DIVISION OF ENGINEERING AND ROADS
A DIVISION OF THE PUBLIC WORKS DEPARTMENT

RE: Painted Hills PRD Floodplain/CLOMR Submittal Review #1

Map 4403

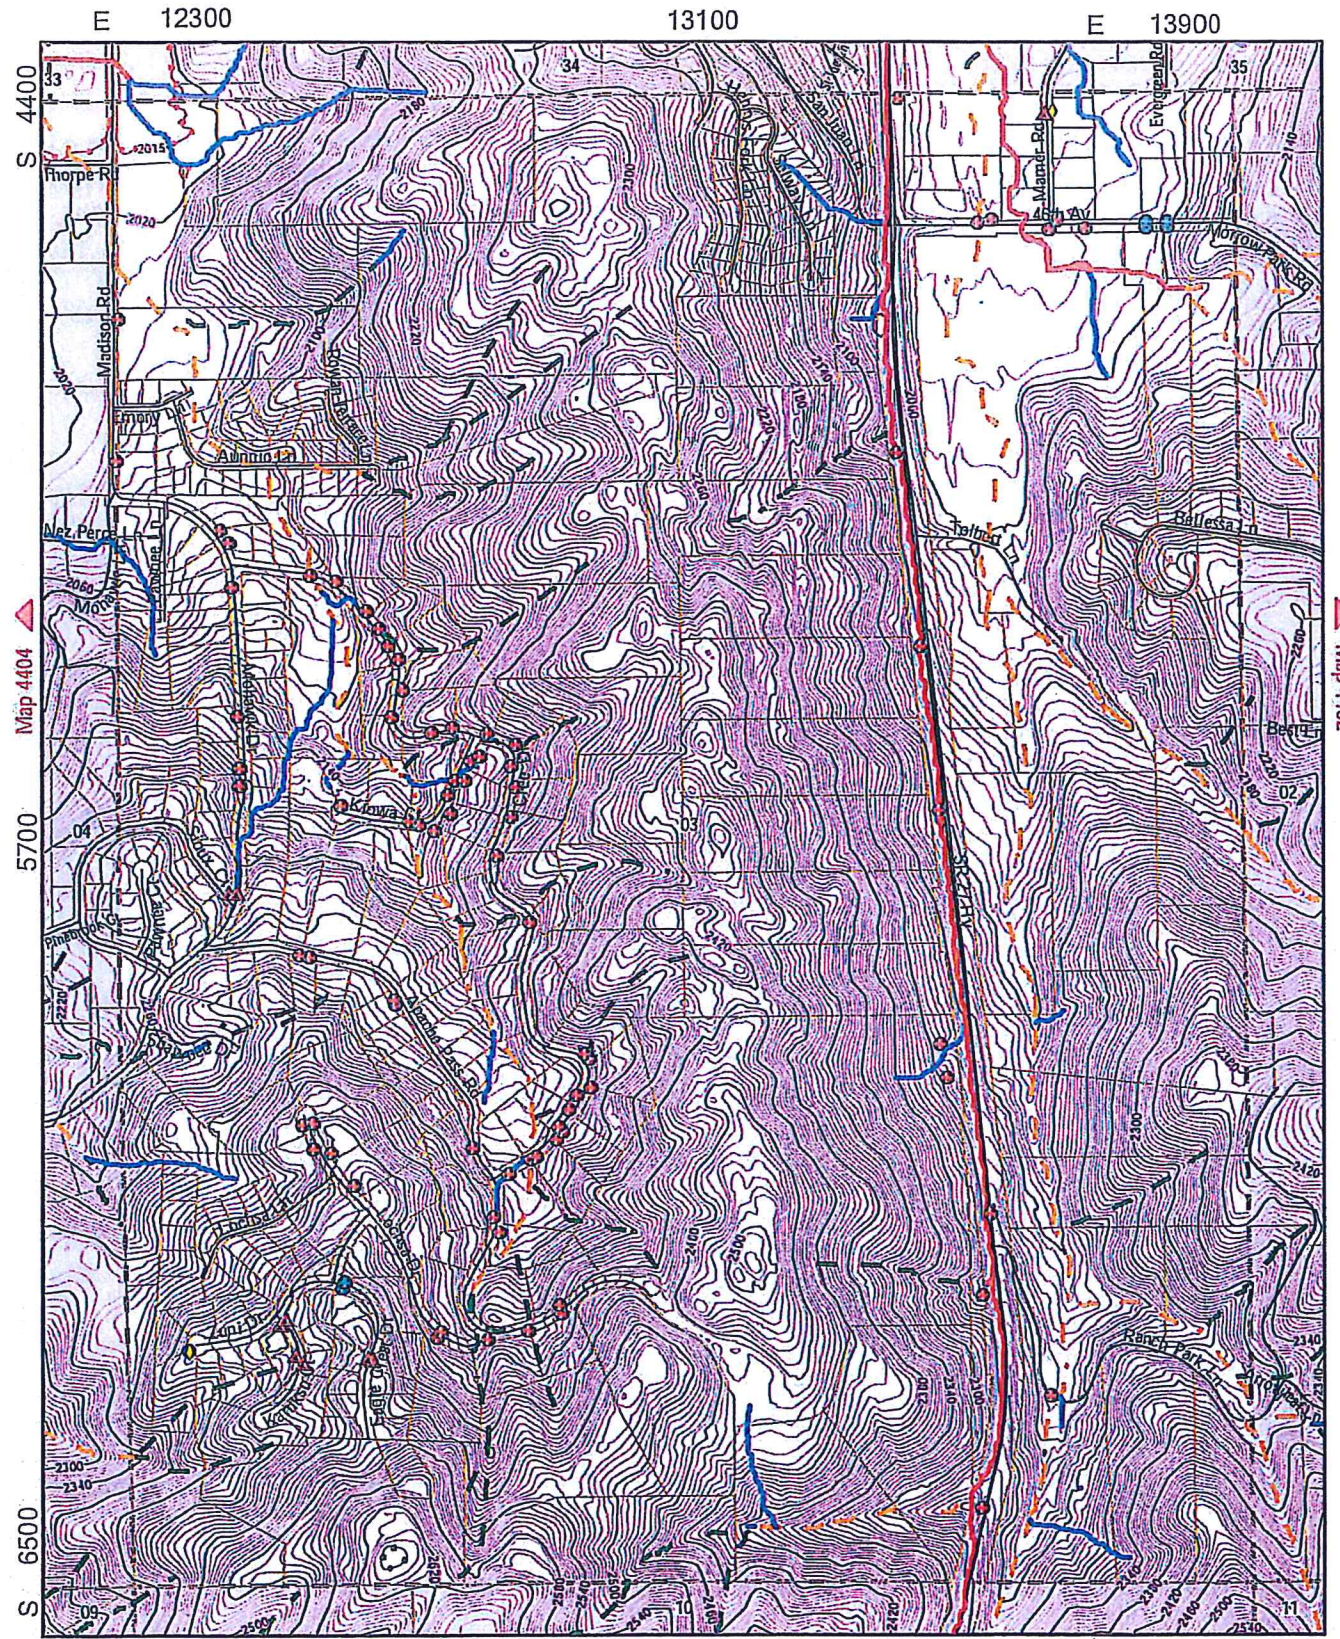
3. FC4.3 – What are the "future Thorpe Road improvements" shown in the South Collection Pond & North Forebay Pond Section? Provide details.
4. FC5.0 - Madison Road Plans - The Madison Road drainage plan will need to effectively distribute the basin flows involved thru the various cross-culverts and drywells that are planned. It's not obvious that the drywell with intakes planned along Madison have connectivity to the various collection point of runoff or shouldn't be extended further north along Madison. Therefore, the off-plat drainage basins between Madison Road and Horizon Hill Lane need to be defined and the peak flows estimated. At the south end of the area the Stormwater Utility mapping indicates an off-plat basin with forked gully's in the unincorporated County with the flow path crossing Madison Road approximately one block north of the Thorpe Road intersection. (See attached topo & stormwater maps).

SECTION 24 T24N R14E M1M

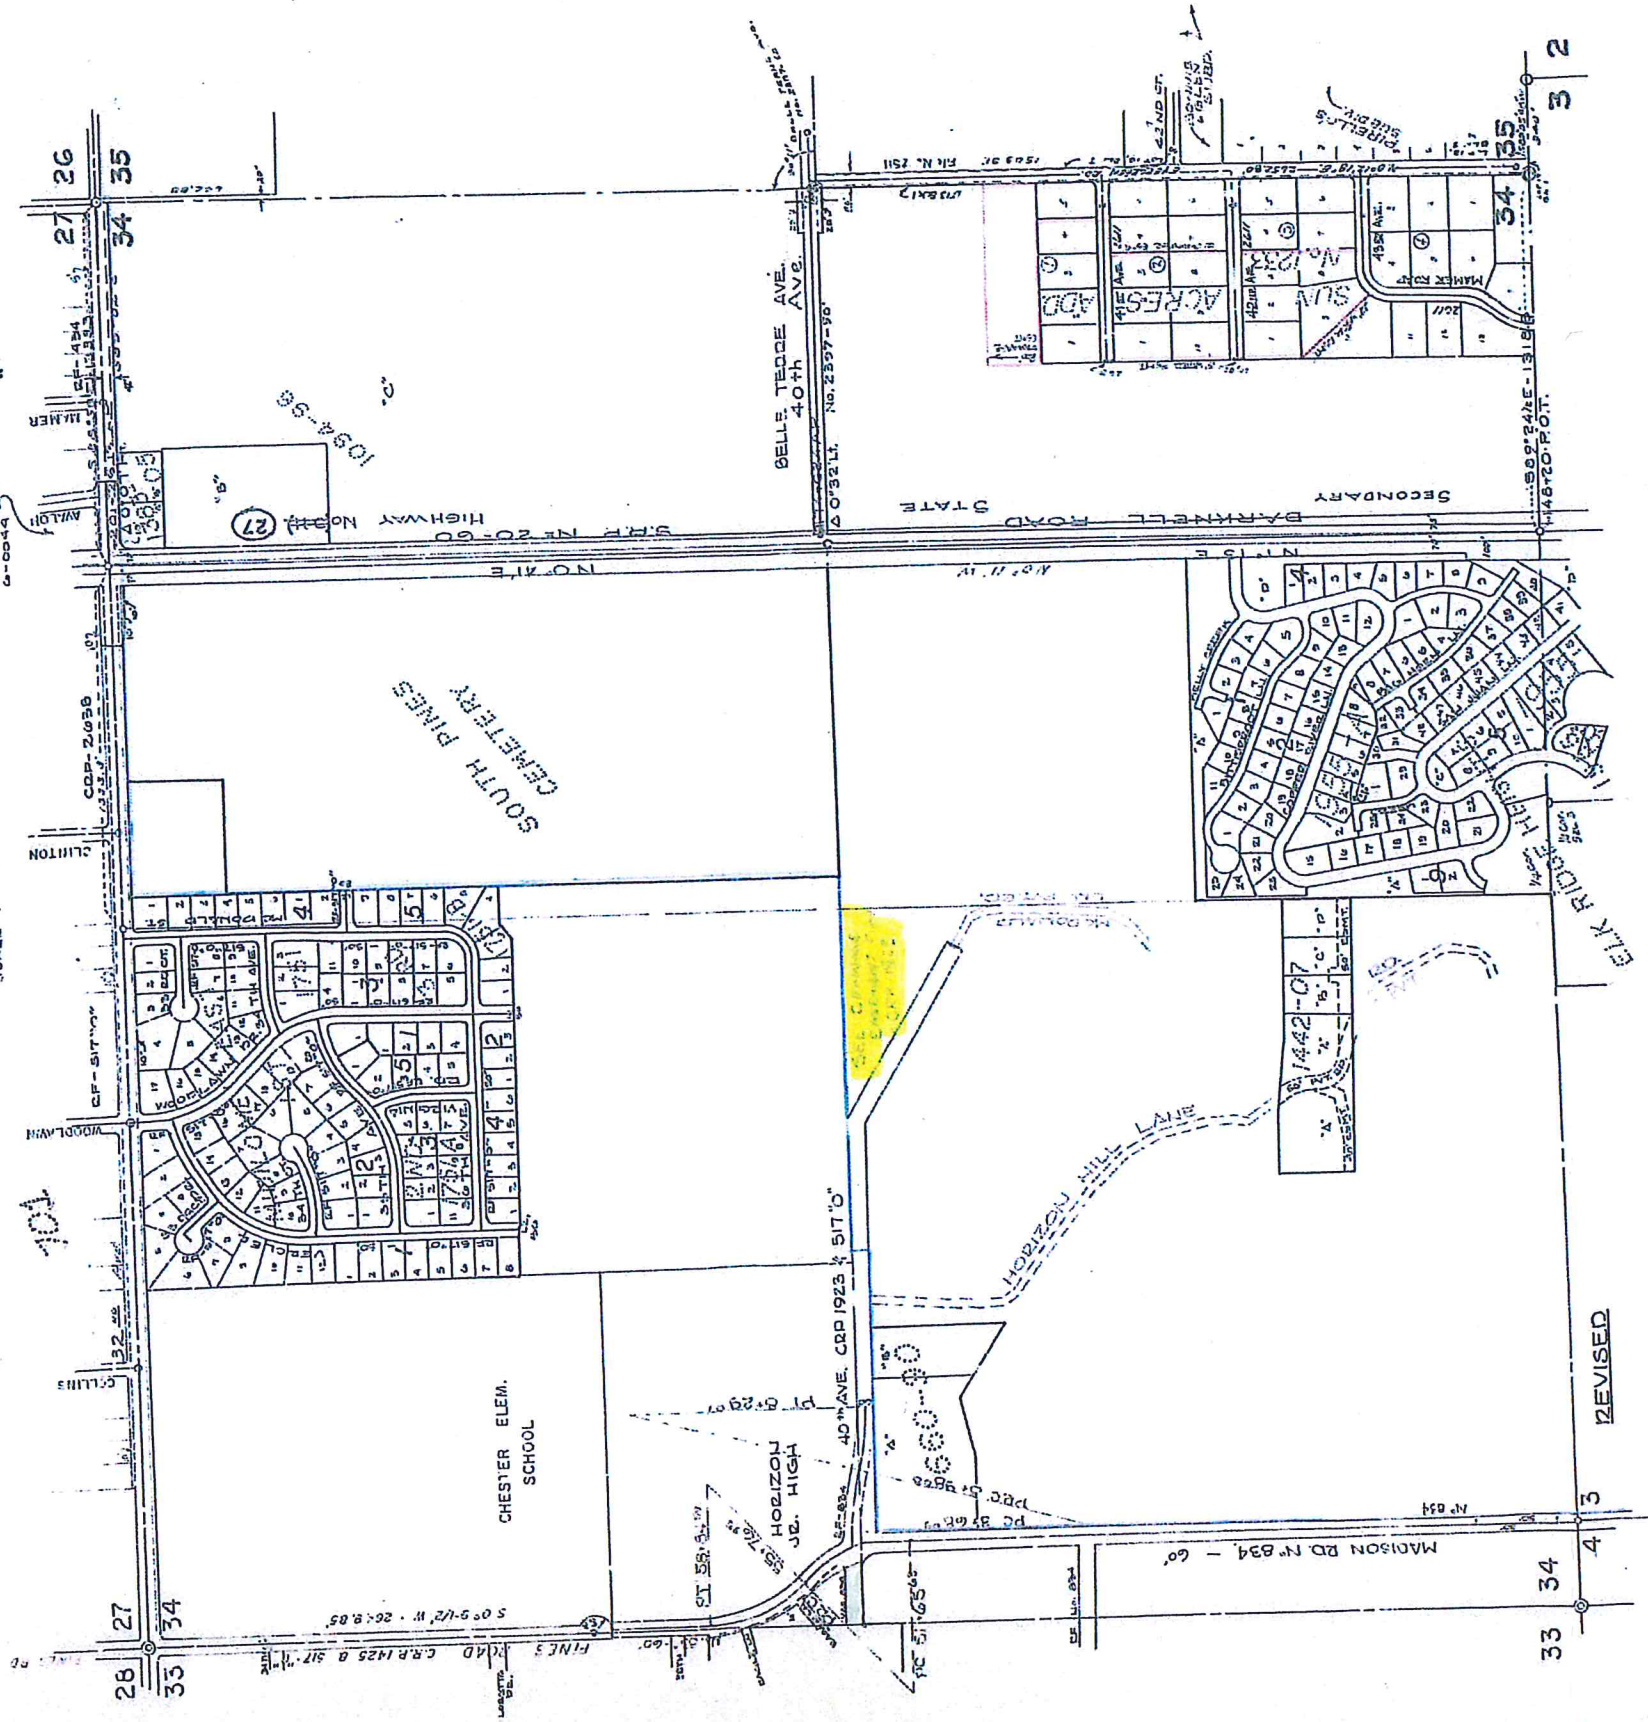
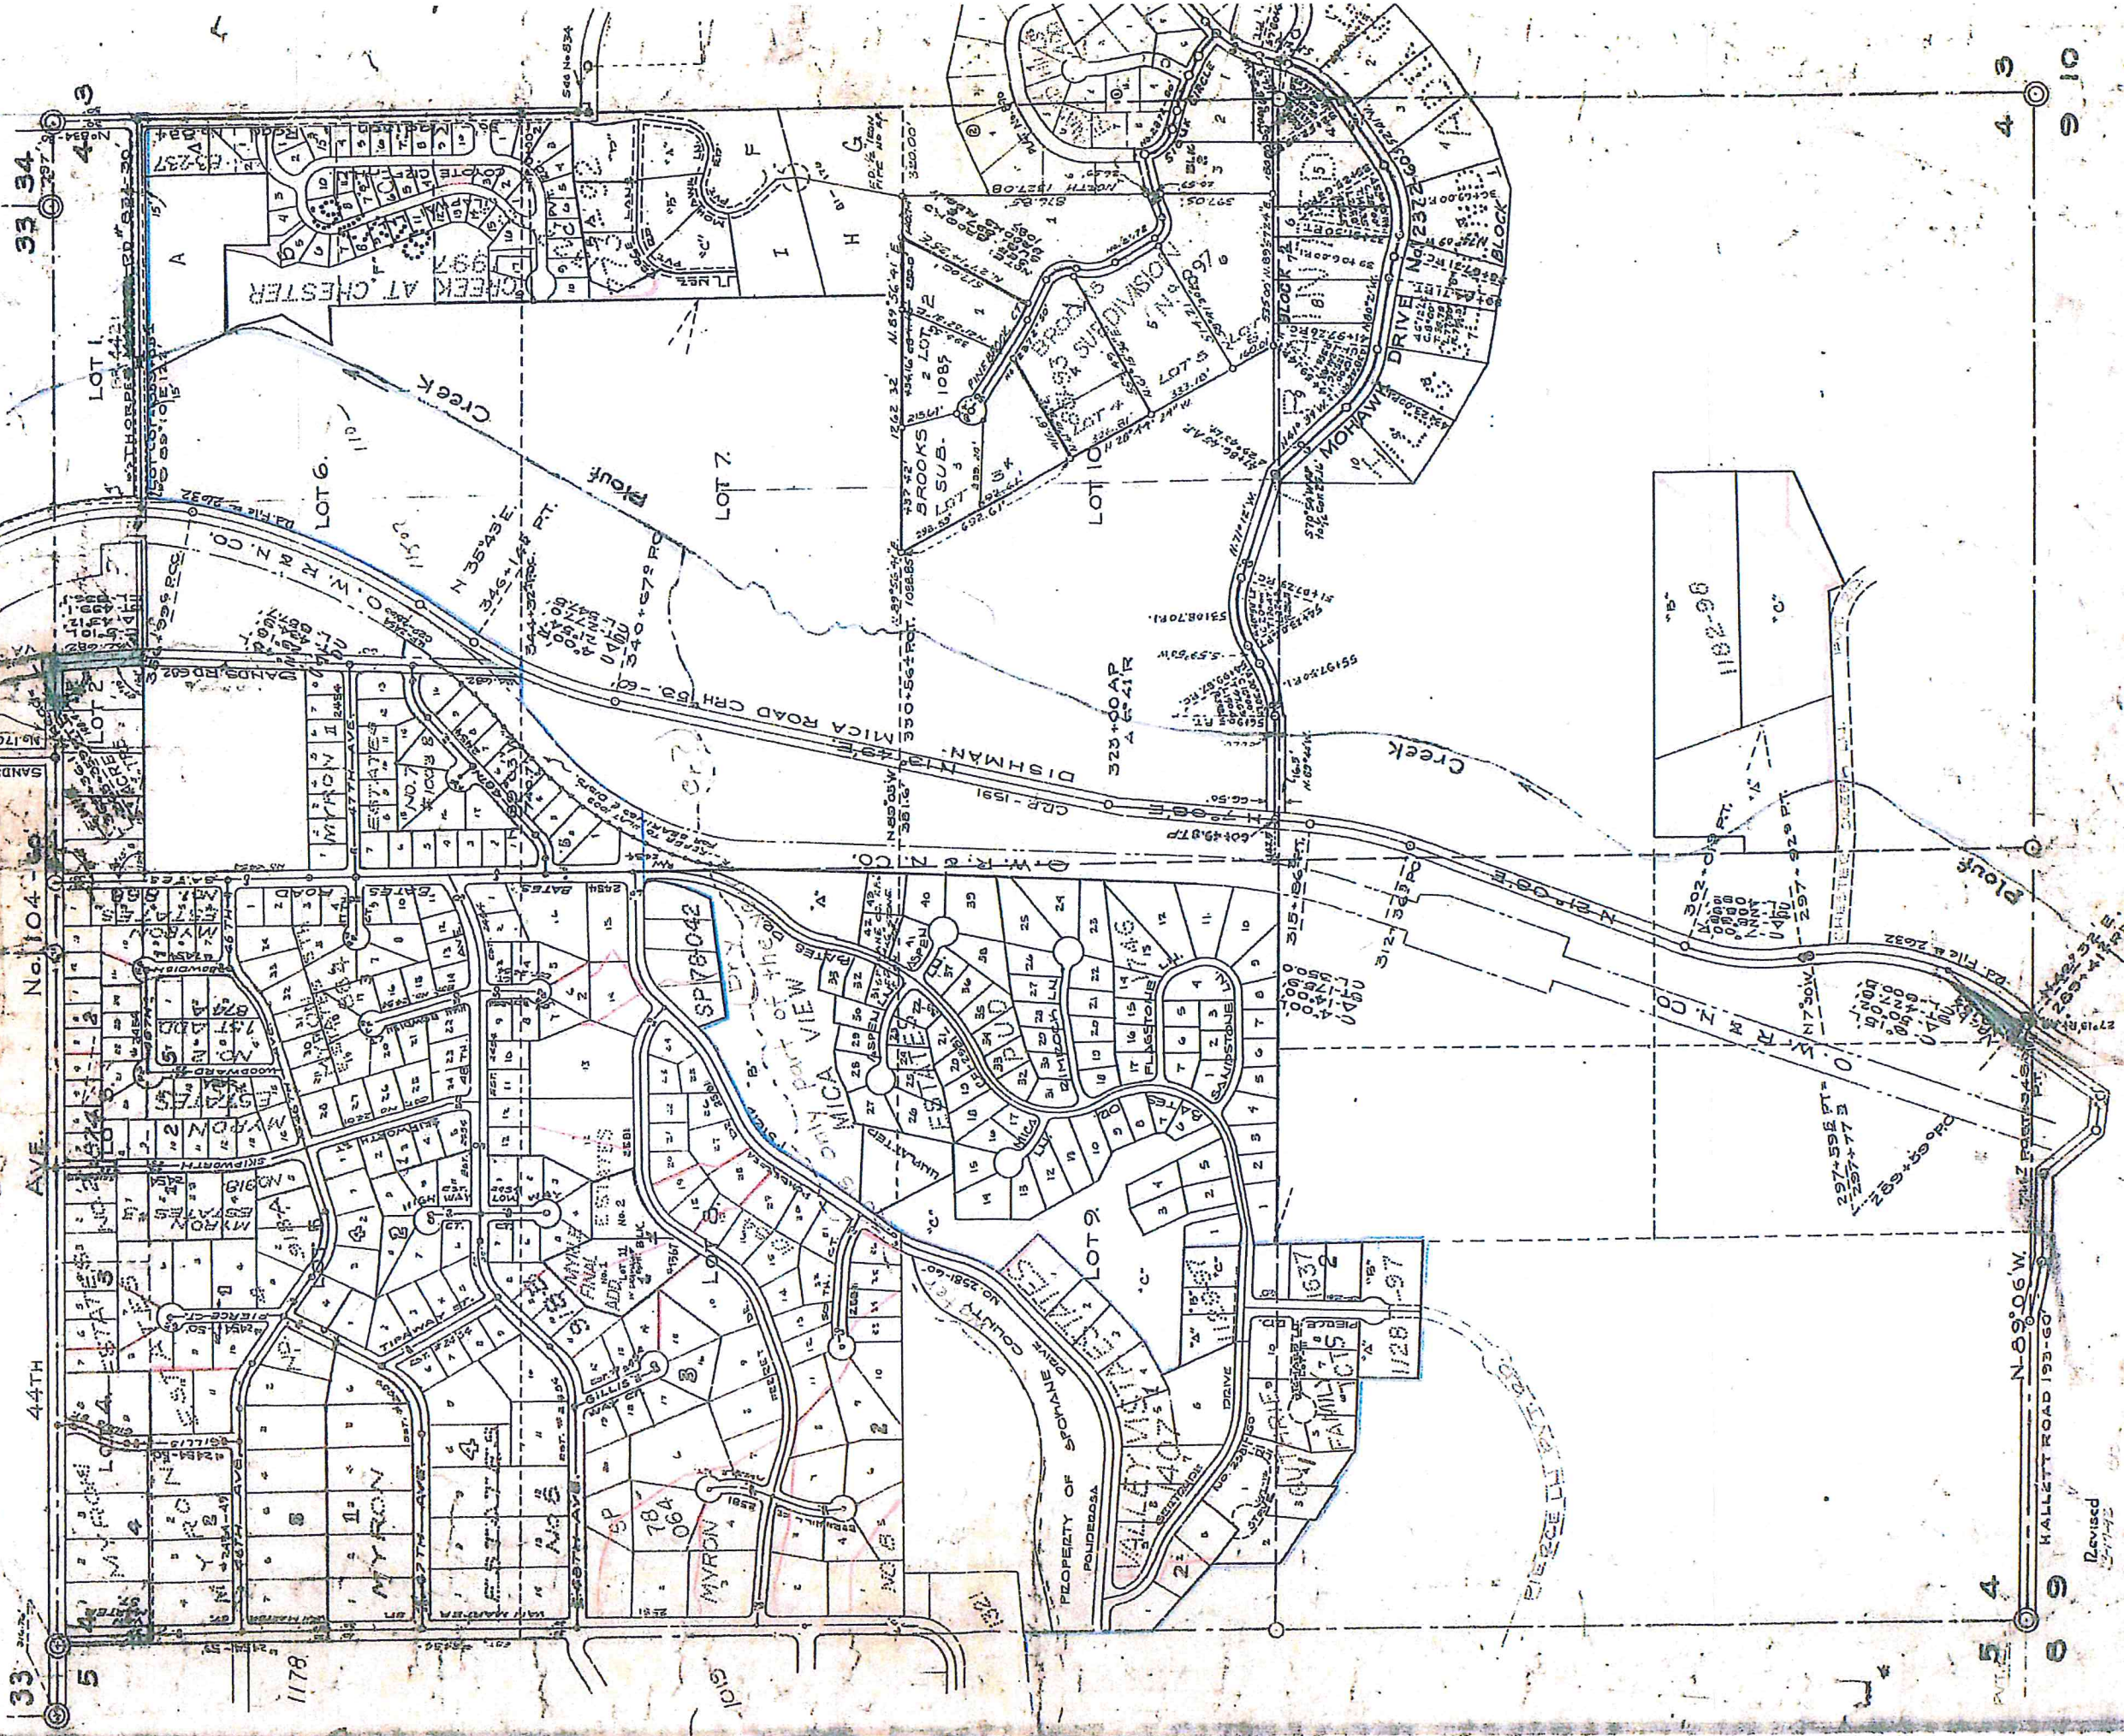
7. The official County Engineer's section map references a drainage easement dedication over the triangle property for CRP No. 1923. We have not located a copy of the easement and assuming at this point that the proposed additional use to intercept flood flows with the drywell farm is consistent with or at least not prohibited in some way by the easement in-place. However, this will need to be verified. Additional easement rights will need to be granted by the property owner of APN No. 45343.9052, if the existing easement does not grant rights for the proposed use outright or the easement is no longer in-place. (See enclosed section maps).
